Stormwater Design Report

Ashville Concourse

State Route 752, Village of Ashville, Ohio
July 26, 2023

Reviewed

VILLAGE OF ASHVILLE, PICKAWAY COUNTY, OHIO
 ASHVILLE CONCOURSE
PRE-DEVELOPED
 TRIBUTARY AREA MAP

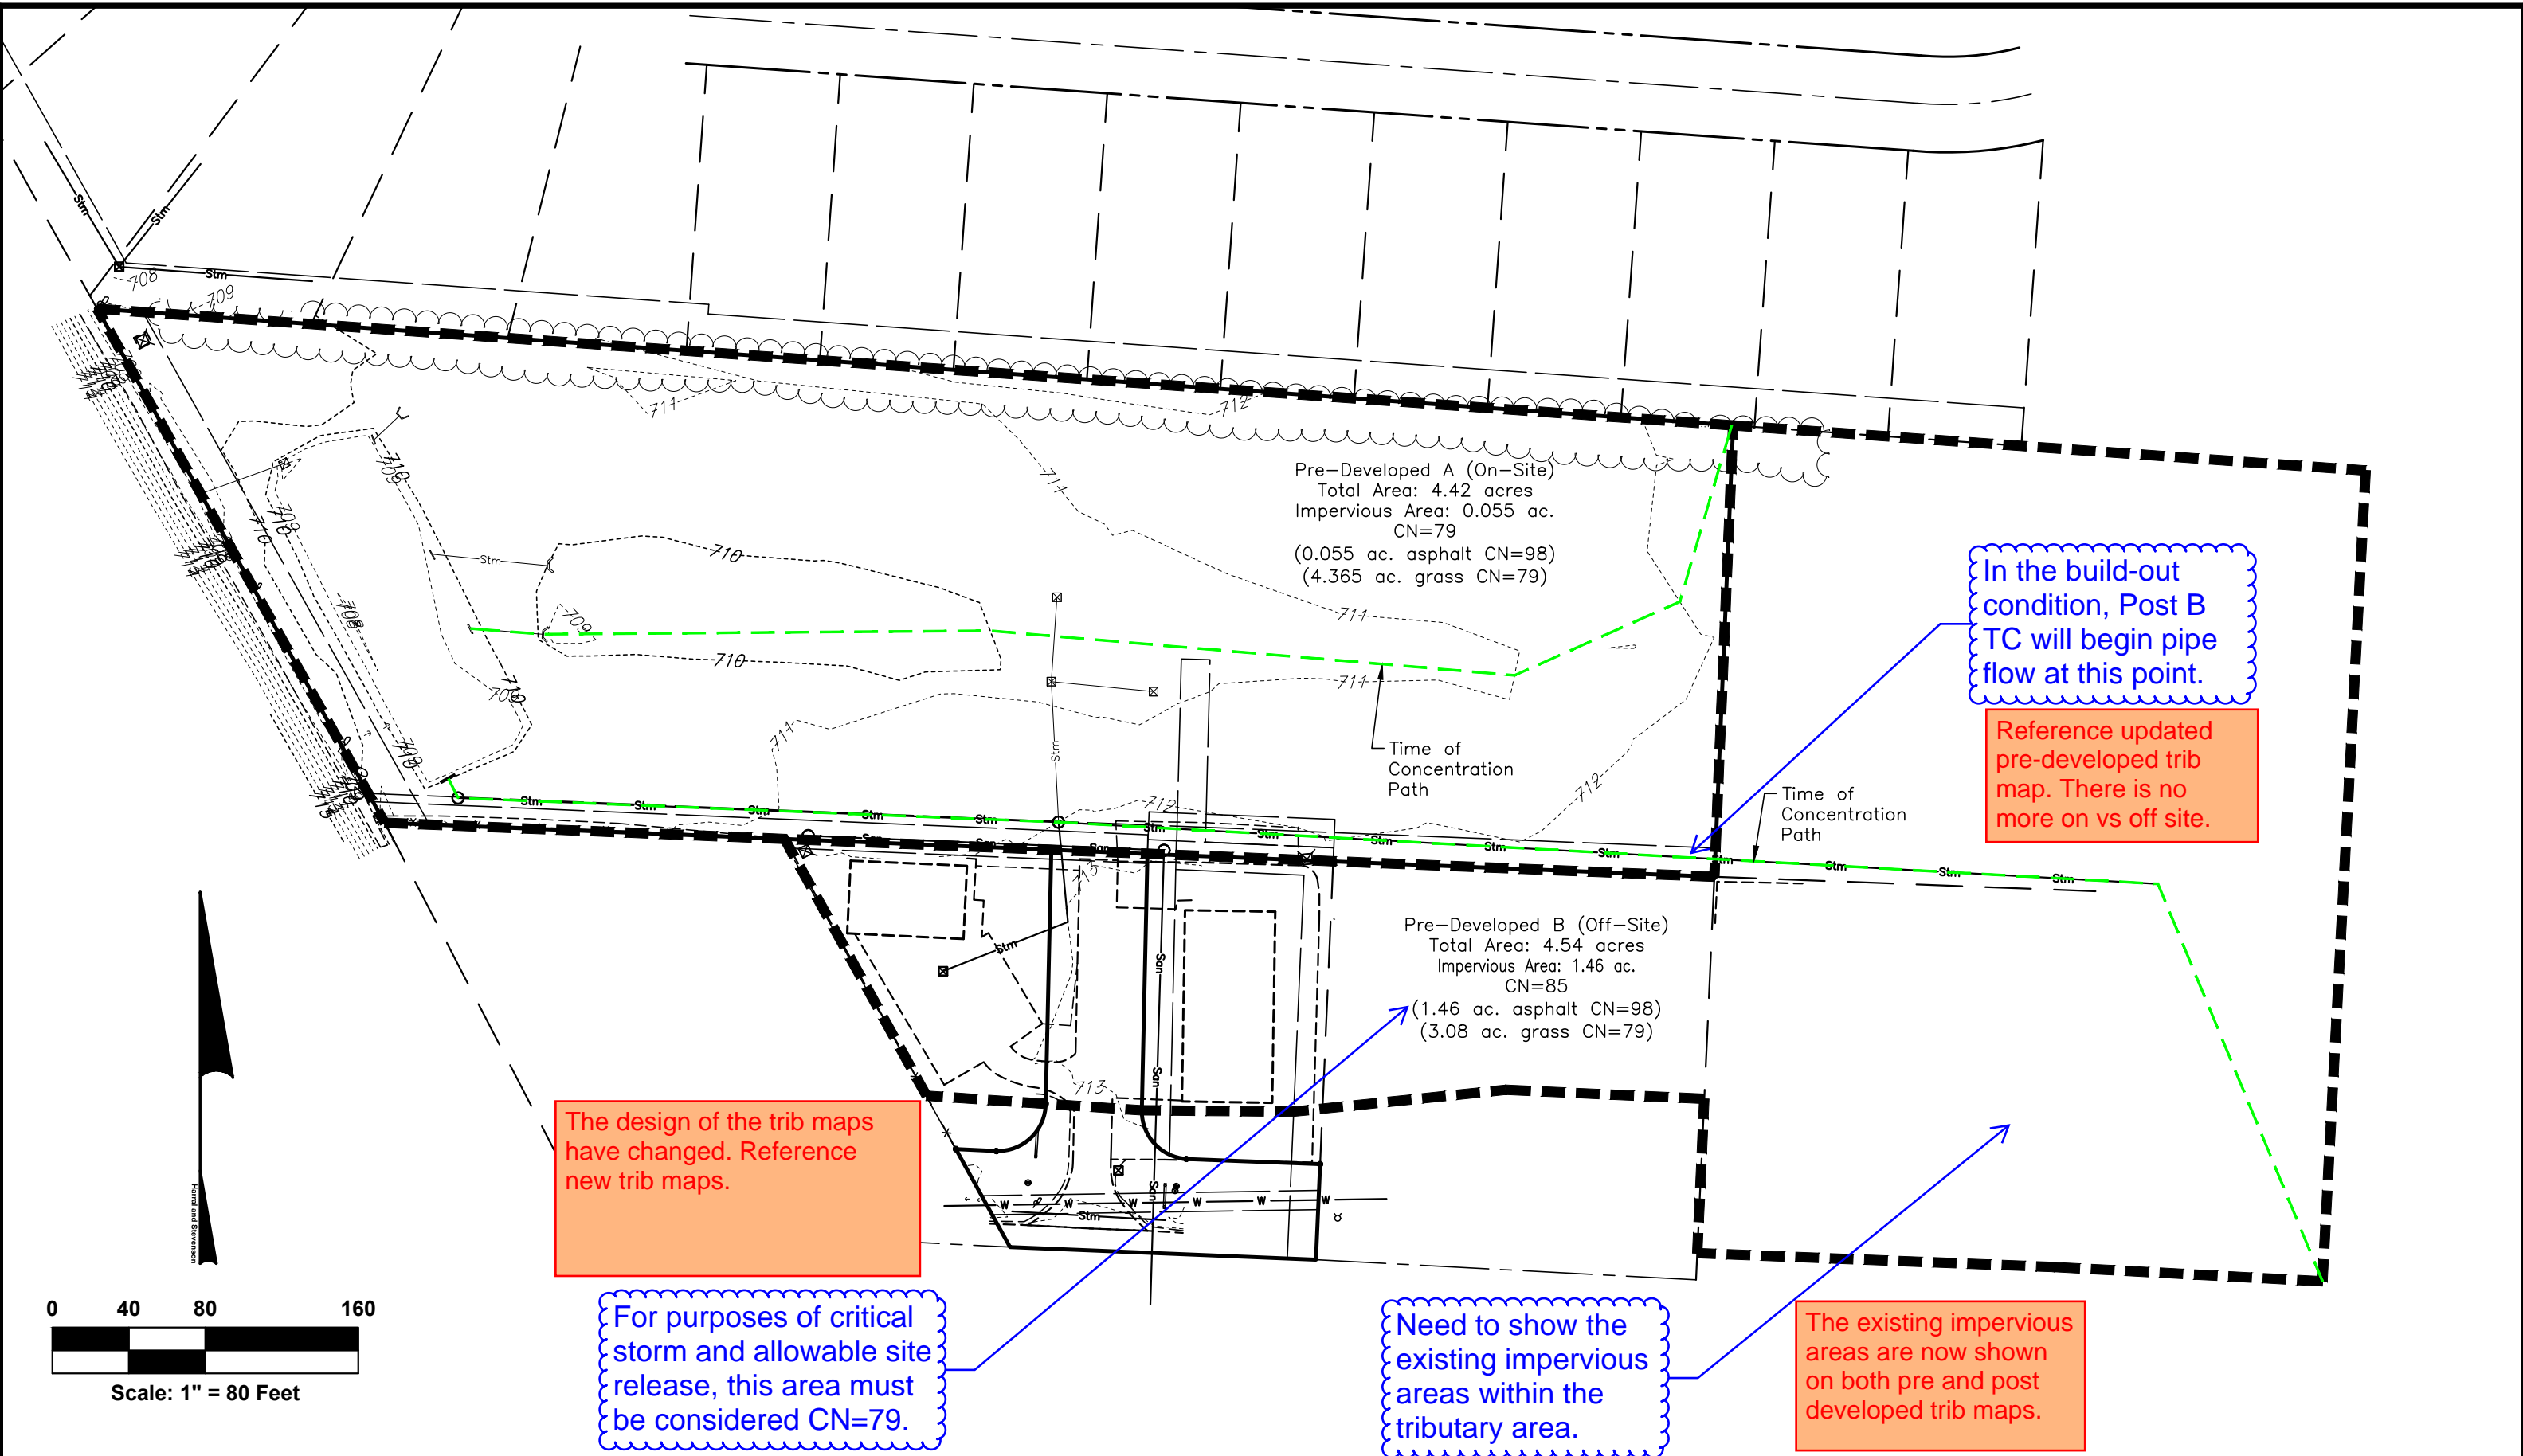
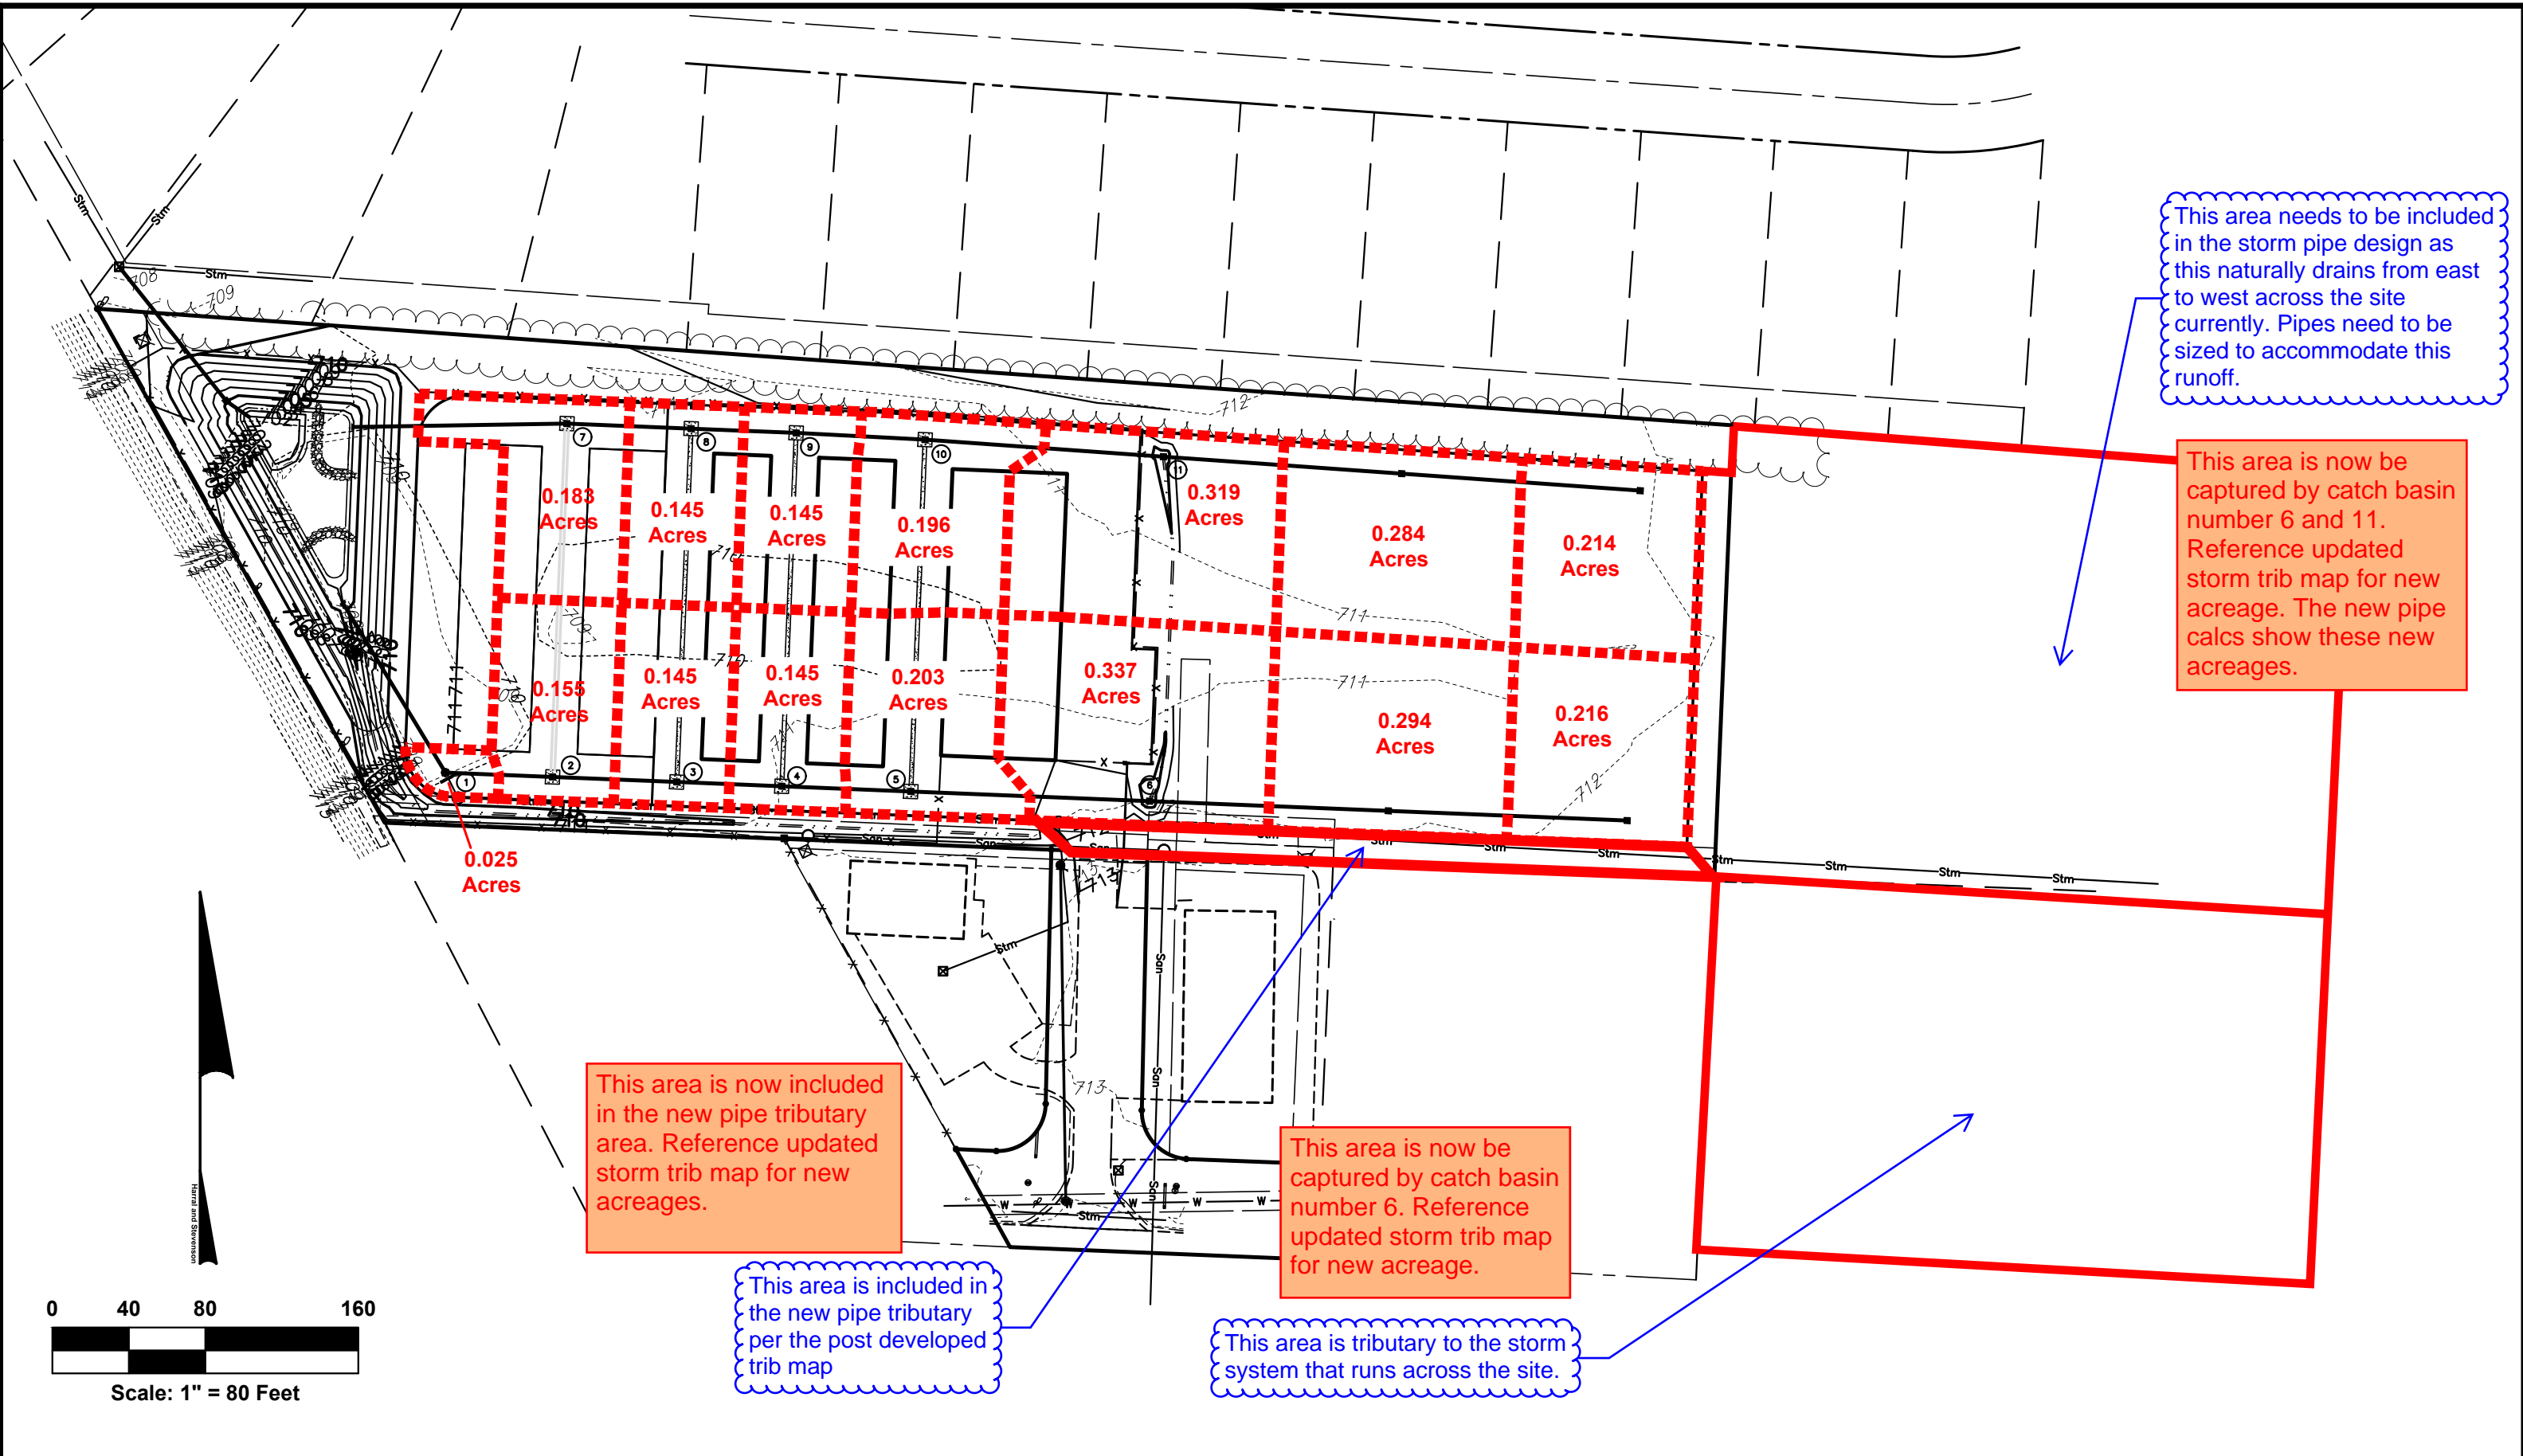
Provide table separating proposed impervious/grass AND future impervious/grass. This will be important for future expansions to determine if additional site analysis is required.

Why is this area not being captured by the catch basins? Contours show drainage is flowing to them. If it is not intended to be caught by the proposed structures, where is it going?

Where is the substation drainage directed? Confirm that there isn't offsite that will route through the basin.

Need to show the existing impervious areas within the tributary area.

The grading plan has changed. This area is flowing south and is now being captured in the catch basins. This area is now included into Post Developed A. Reference updated pre and post tributary maps for new boundaries.

A table has been added to this sheet to show the difference between the impervious and pervious area for the existing, proposed, and future conditions.

Grading plan has changed. This area is now being directed to the basin and calculated in Post Developed A.

About half of the substation is draining directly onto our site and into the basin. Reference updated pre and post trib maps for new boundary.

The existing impervious areas are now shown on both pre and post developed trib maps.

Postdeveloped A

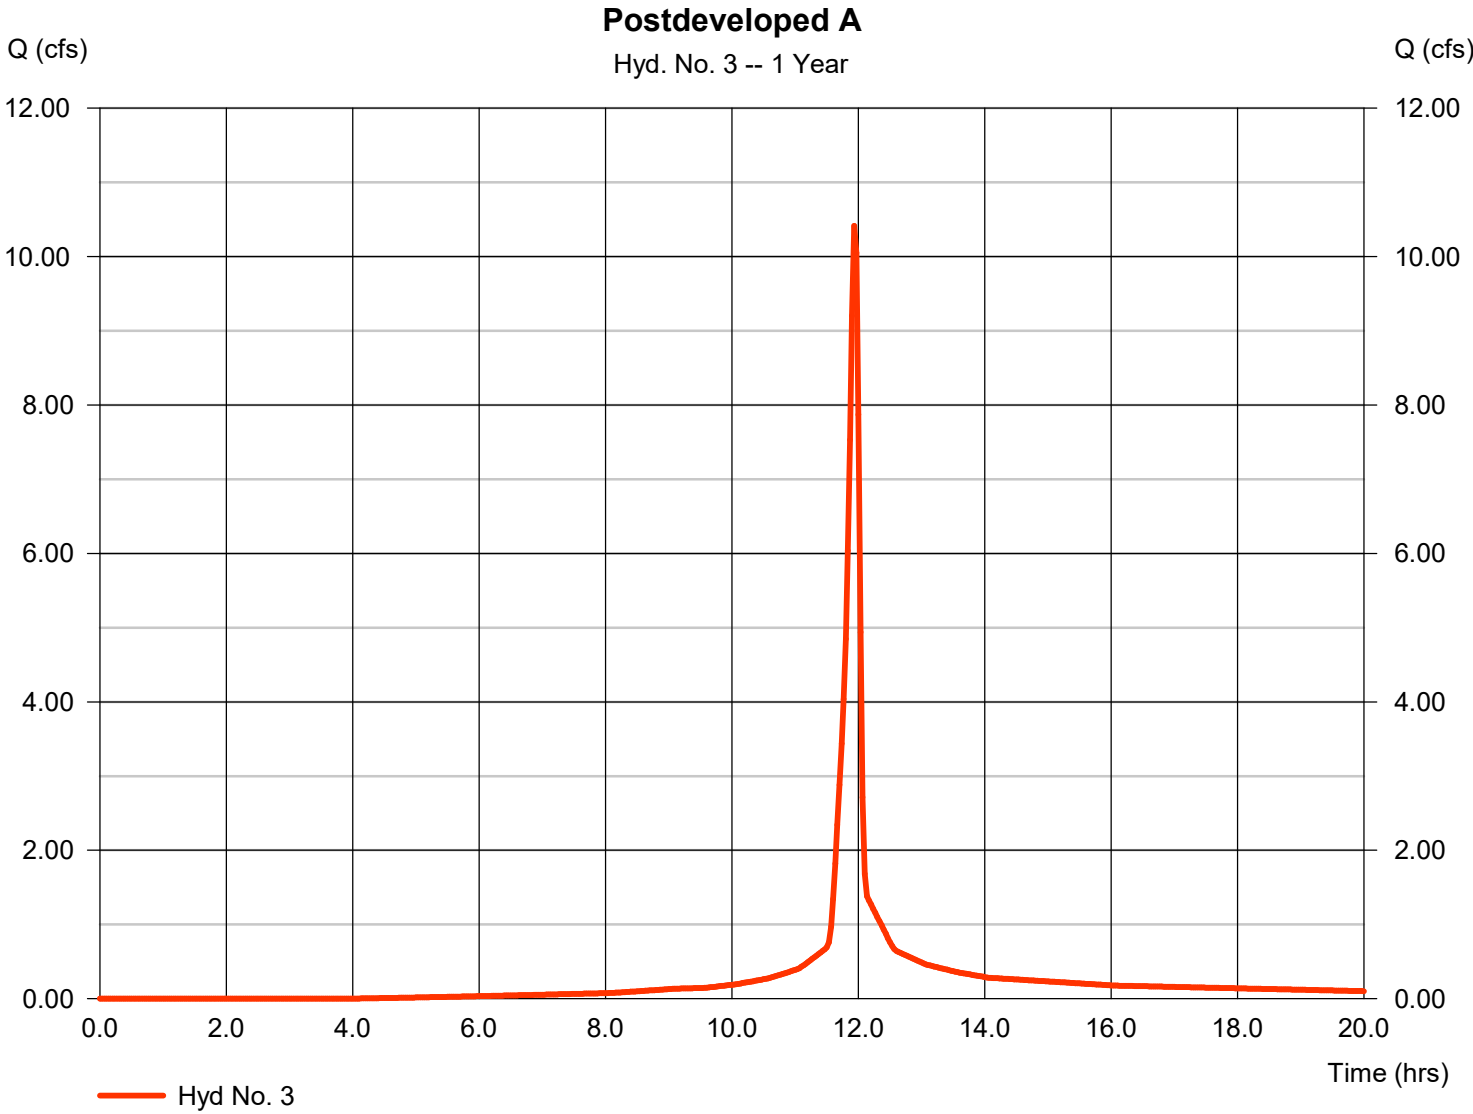
Storm design sheets call for 10 min tc.

This time of concentration has changed because of the new pre and post developed trib maps.

Postdeveloped B

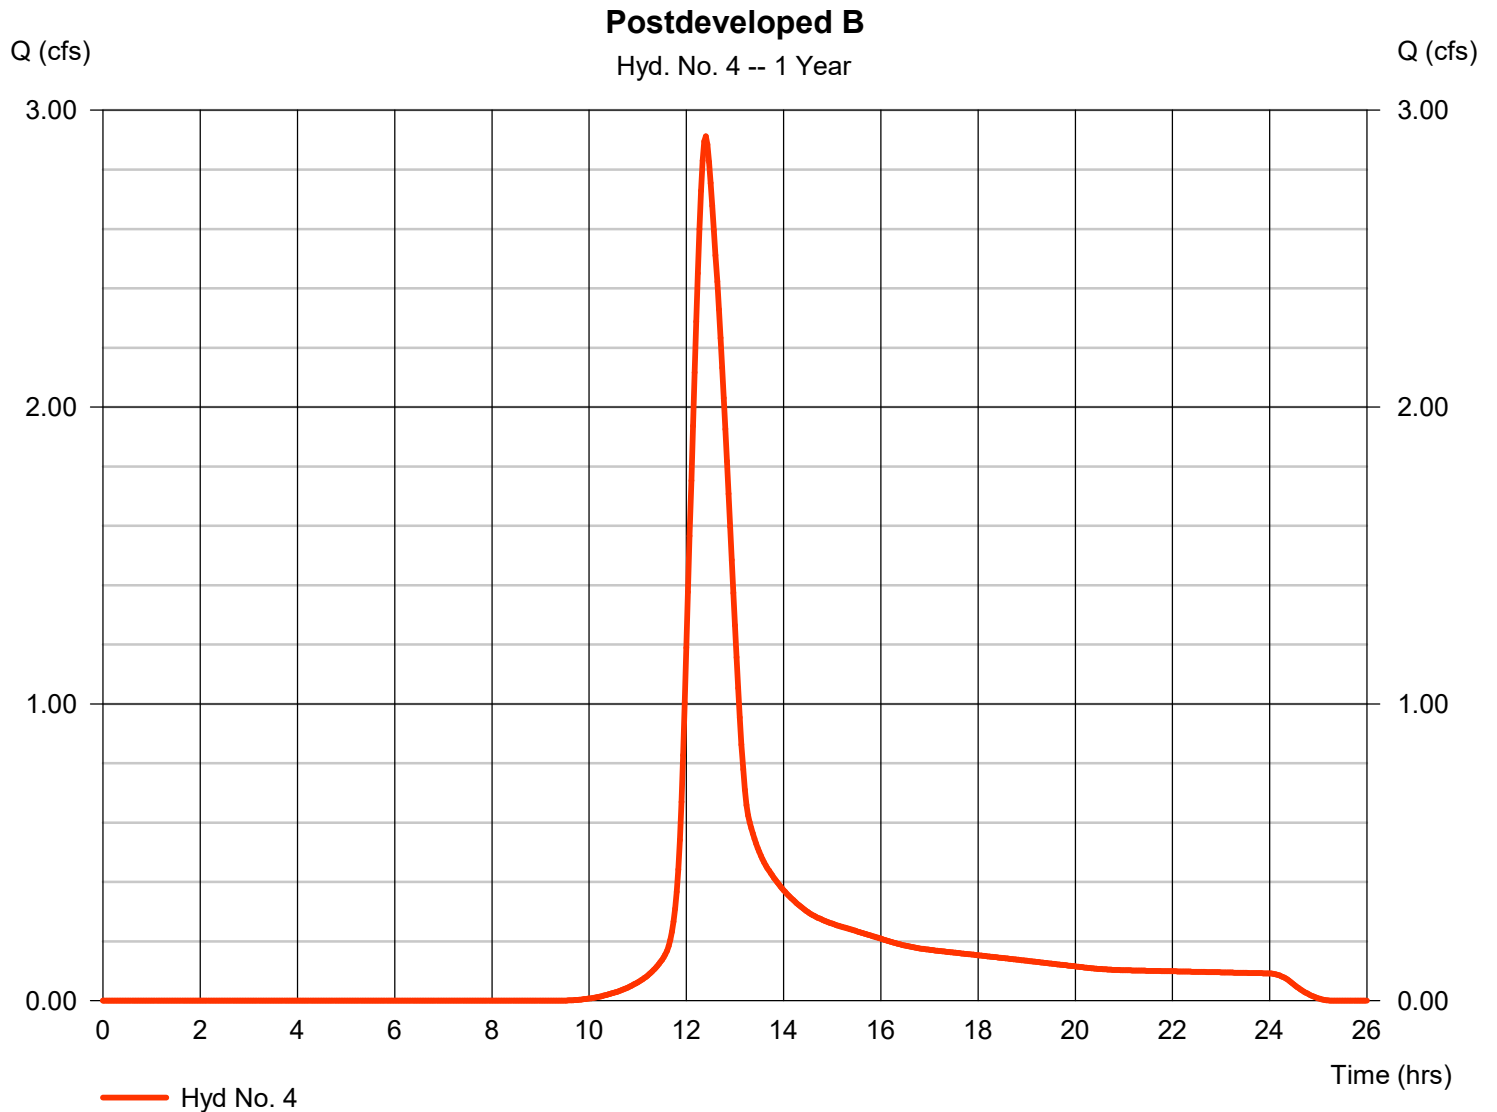
This will be pipe flow
See post trib map
comments

The pre and post
developed trib maps have
changed.
